Agenda Item #4

Certified Record 2025-47-CA

360 Dauphin Street

Alterations to south facade

D INTERIOR ELEVATION / SECTION
SCALE: 1/4" = 1'-0"

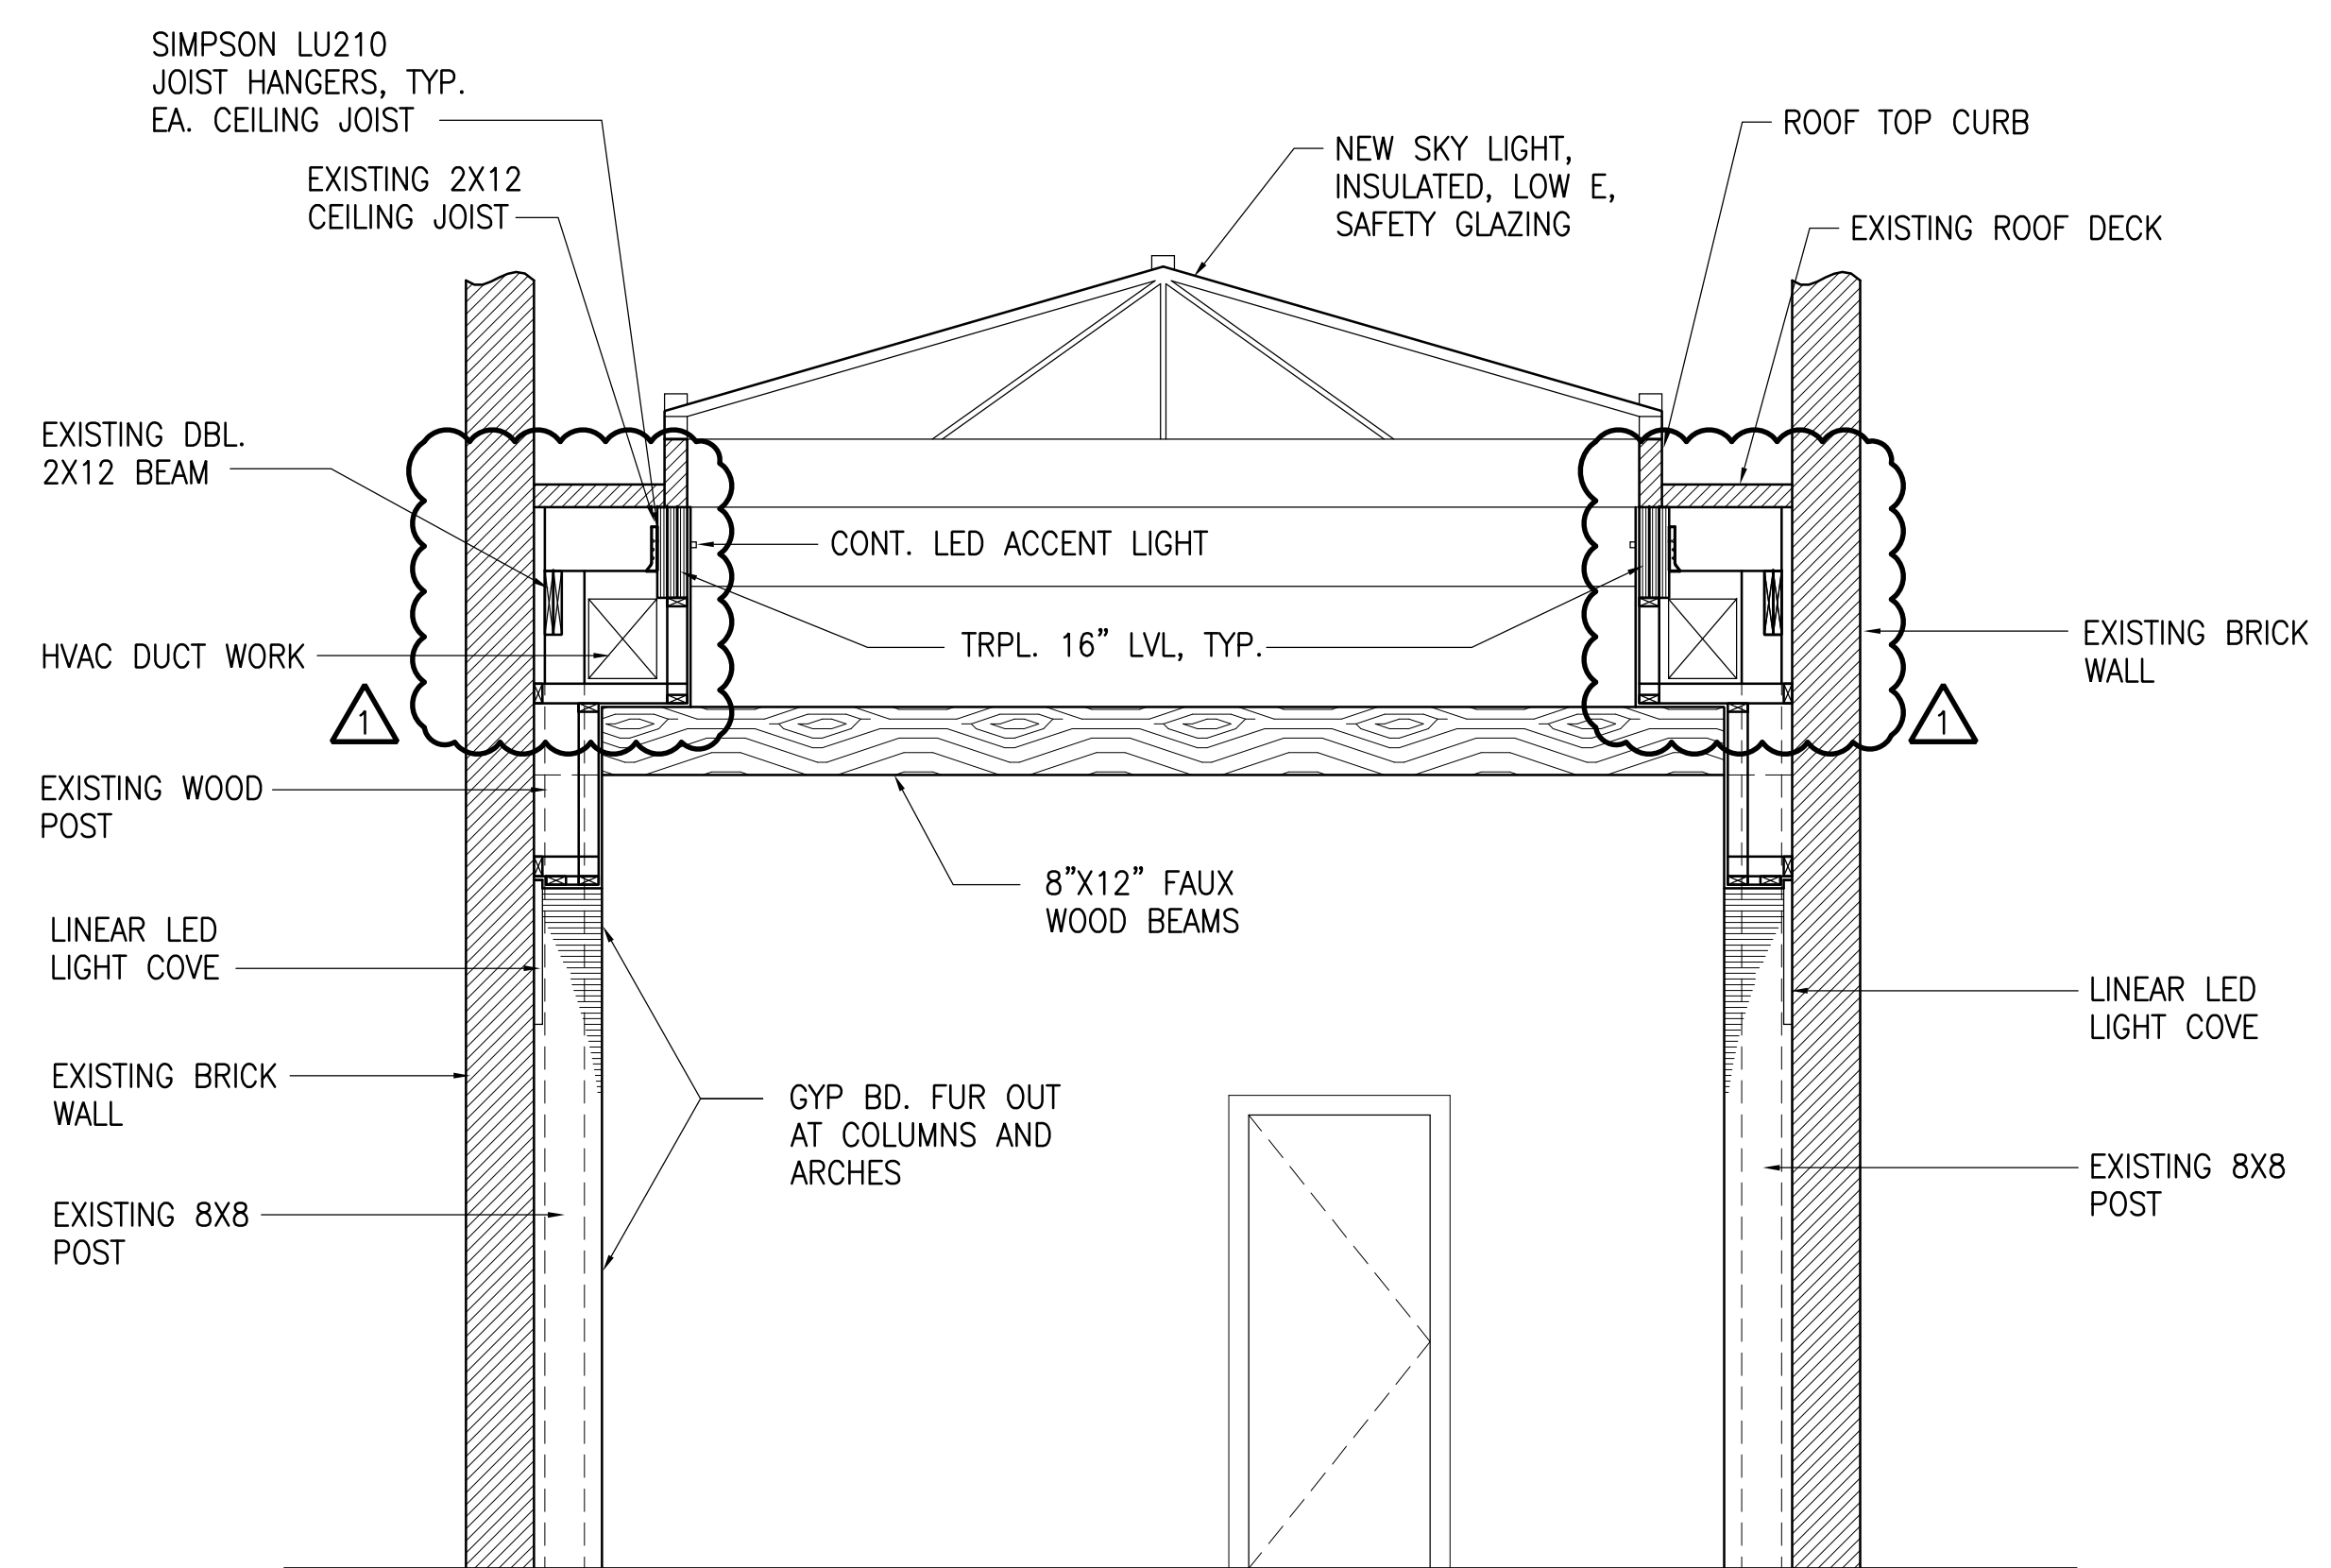
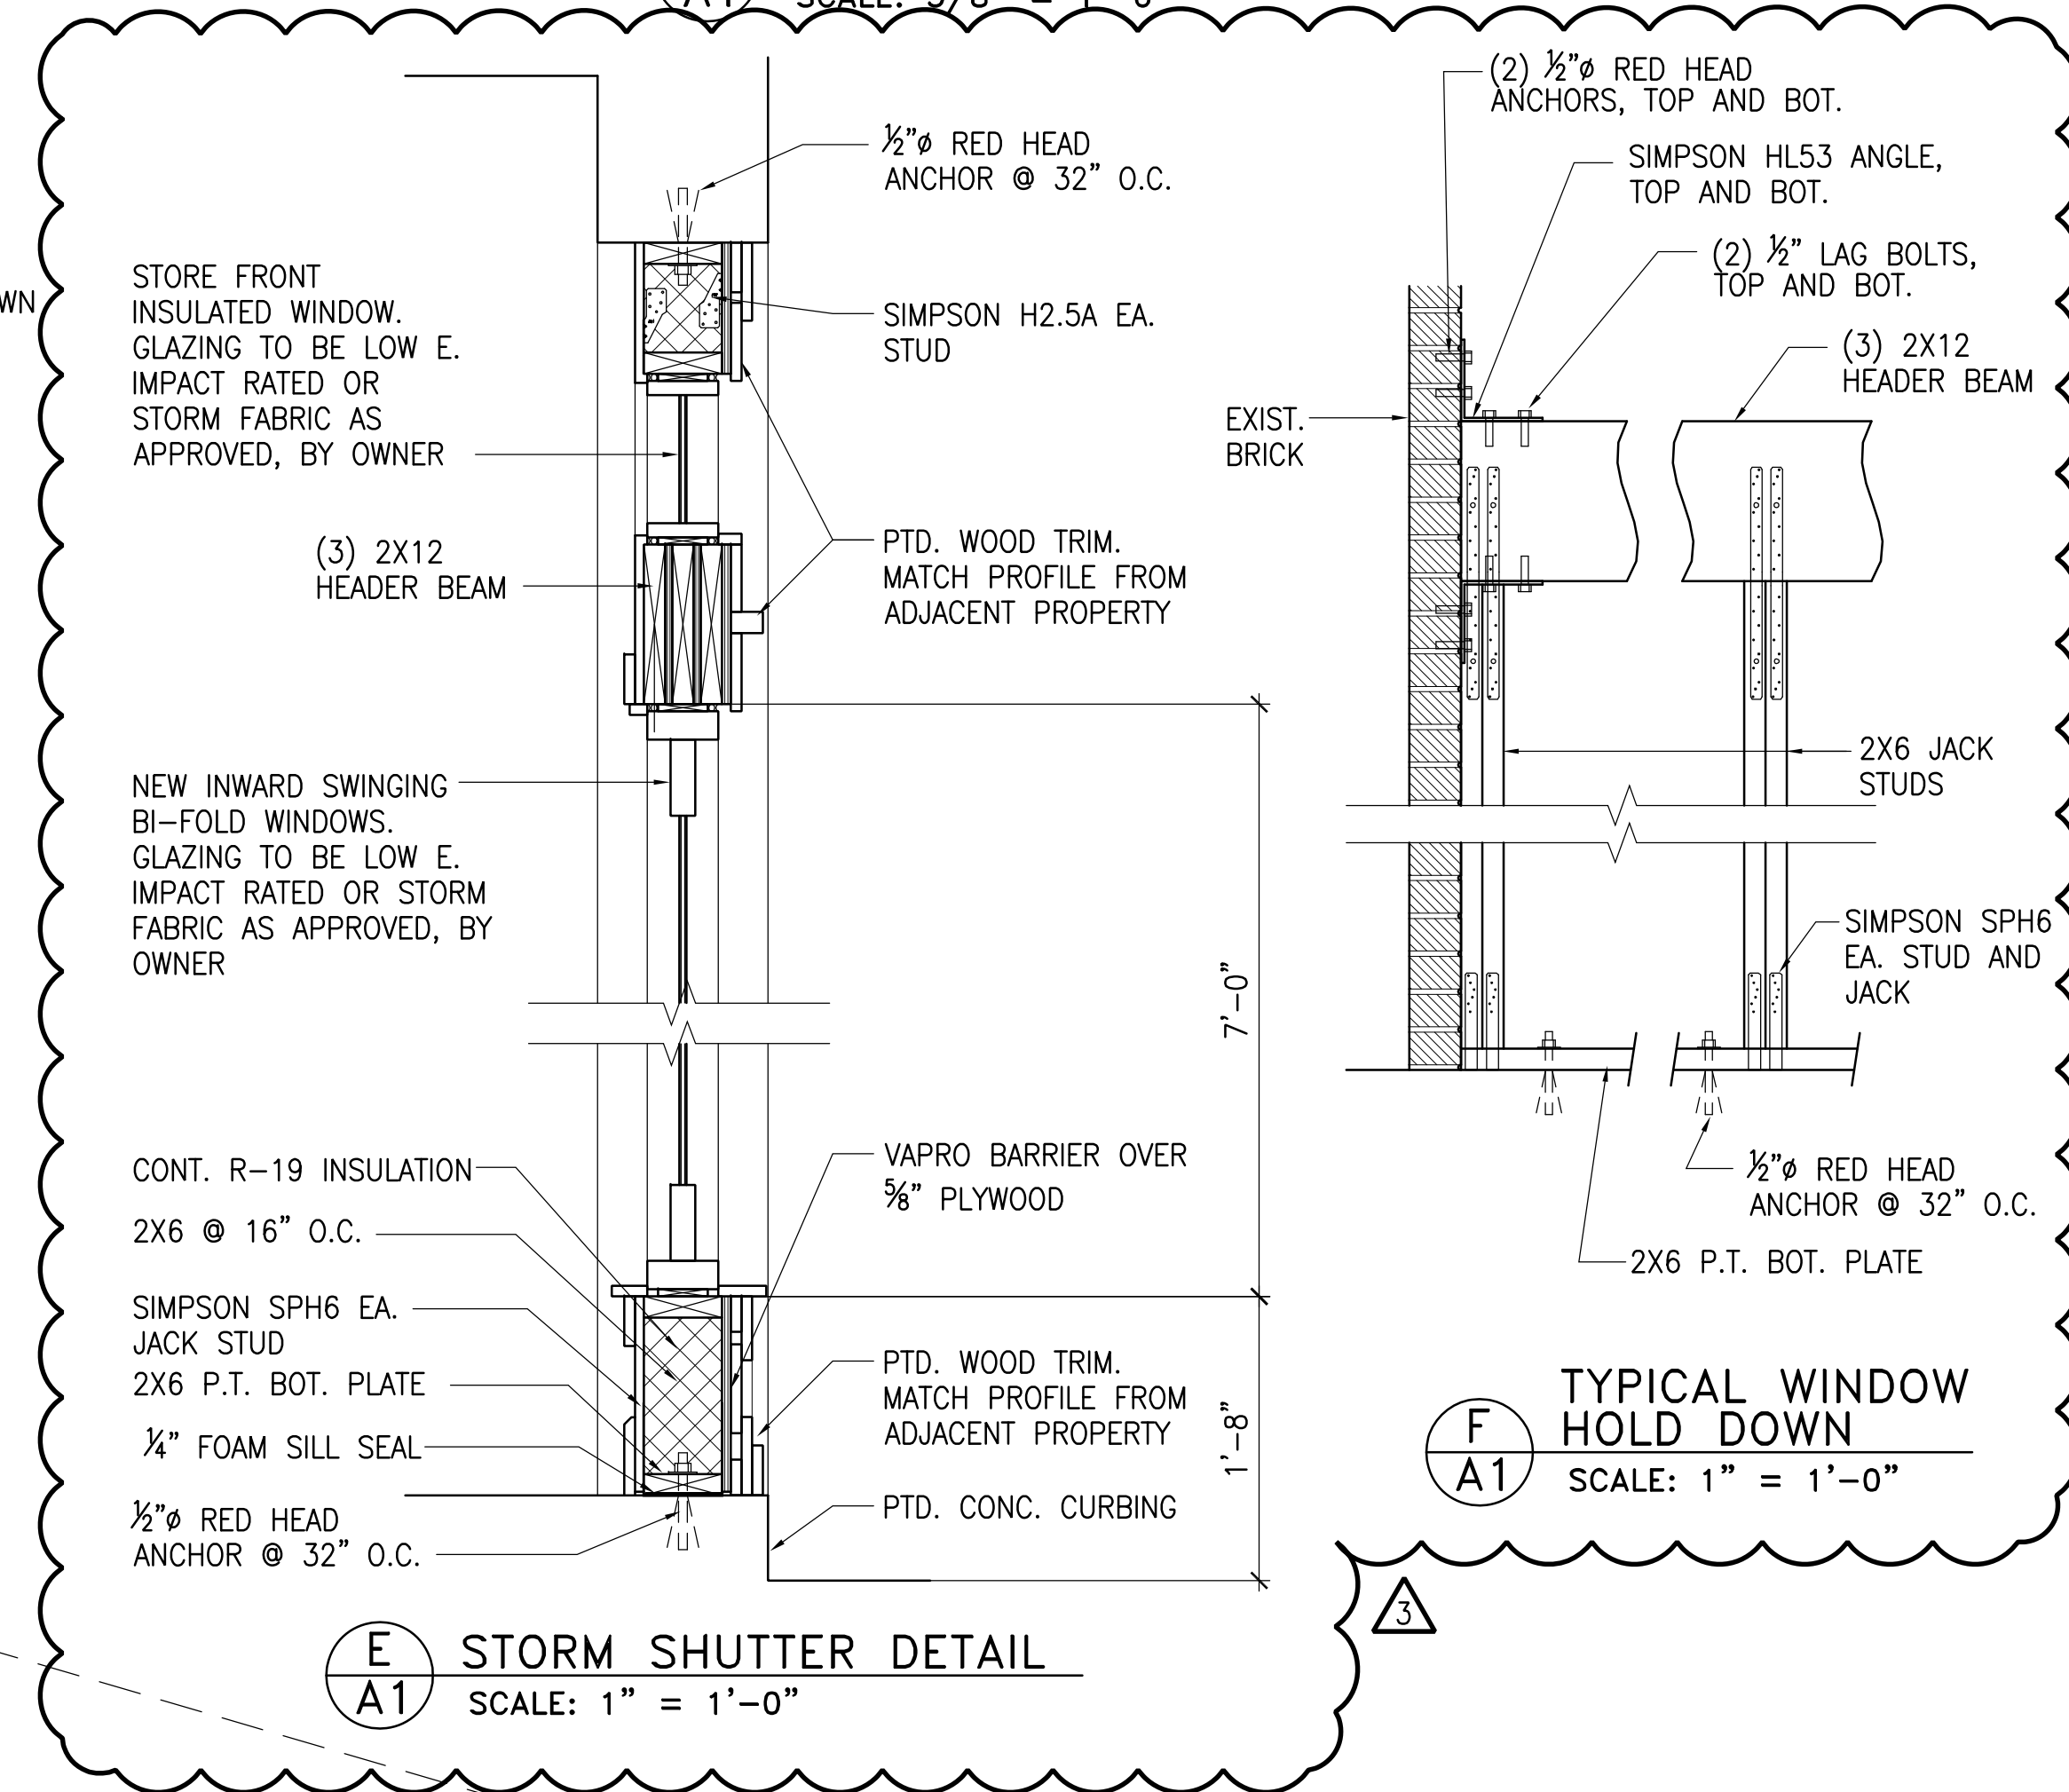
There is no storefront extant on the facade in question, and photographic evidence is insufficient for replicating the form, orientation, or details of an original or historic storefront in this location. Photographic evidence shows that a chamfered recessed glass-and-aluminum storefront existed in 1981, but the storefront shown is clearly not original. The photograph shows that a transom window had been either painted over or boarded. The transom is flush with the facade, suggesting that an earlier storefront may have been flush rather than recessed. At least one panel of a semi-reflective cladding material has been removed or fallen away, revealing brick that appears to have been painted. In short, existing photographic evidence does not provide one specific original or historic design to emulate.

The proposed wood storefront and bank of windows with transoms will imitate the proportions and fenestration patterns of storefronts on adjacent buildings, especially at 362 Dauphin Street. The proposed design meets the Guidelines requirements in that it includes a bulkhead below the window, uses a high proportion of transparent glass, and uses replacement materials that are visually compatible with the original. The banded windows will emulate the proportions and transparency of a traditional storefront and, when open, will encourage interaction between the building interior and the public realm at least as much as a storefront entrance would have done. The aluminum windows are also visually compatible with the Wilkins-Higgins and other neighboring buildings. (7.3, 7.8, 7.18, 7.19)

The application also proposes installing a low-e film on the windows. The Guidelines discourage the use of opaque window treatments, so any applied window films should maintain an appropriate level of transparency. (7.19)
